Access Compliance Report

Public Rights-of-Way

(Curb Ramps)

Intersection ID: 12216	Main Street: ASHLEY_RD	Cross Street: LUMINA_AV	Location: W
ADA ID: 10E45D8AEF90	Ramp Type: PerpDiag	Initial Pass/Fail: Fail	Overall Compliance: No
		Severity Score: 8.75

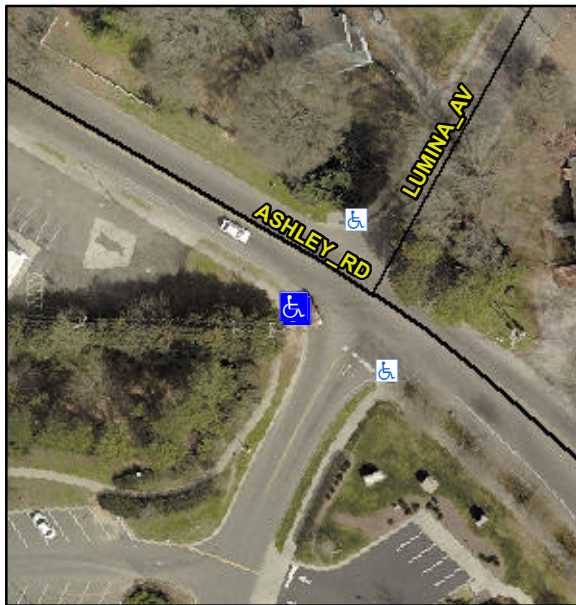
Not Found, R304.5.1

Compliance	Description	Data	Compliance	Description	Data
N/A	Ramp Length (in)	25.0	Yes	Ramp Slope (%)	6.7
No	Ramp Width (in)	47.5	Yes	Ramp XSlope (%)	1.1
N/A	Flare Type LT	N/A	N/A	Flare Type RT	N/A
N/A	Flare Slope LT (%)	N/A	N/A	Flare Slope RT (%)	N/A
N/A	Flare Traversable LT?	N/A	N/A	Flare Traversable RT?	N/A
N/A	Landing Length (in)	N/A	N/A	DWS Provided?	N/A
N/A	Landing Width (in)	N/A	N/A	DWS Contrast?	N/A
N/A	Landing Slope (%)	N/A	N/A	DWS Length (in)	N/A
N/A	Landing X Slope (%)	N/A	N/A	DWS Full Width?	N/A
N/A	Landing Curb? (Y/N)	N/A	N/A	DWS Offset (in)	N/A
N/A	Shared Landing?	N/A			
N/A	Gutter Ponding?	N/A	N/A	Gutter Slope (%)	N/A
N/A	Gutter Lip Ht (in)	N/A	N/A	Gutter X Slope (%)	N/A
N/A	Painted X Walk1?	No	N/A	Painted X Walk2?	No
	X Walk 1 Direction	To SE		X Walk 2 Direction	To NE
N/A	X Walk 1 Width (in)	N/A	N/A	X Walk 2 Width (in)	N/A
	X Walk 1 Slope (%)	1.4		X Walk 2 Slope (%)	2.6
	X Walk 1 X Slope (%)	1.8		X Walk 2 X Slope (%)	3.8

Remove & Replace Curb Ramp With Two New Directional Ramps or Equivalent.
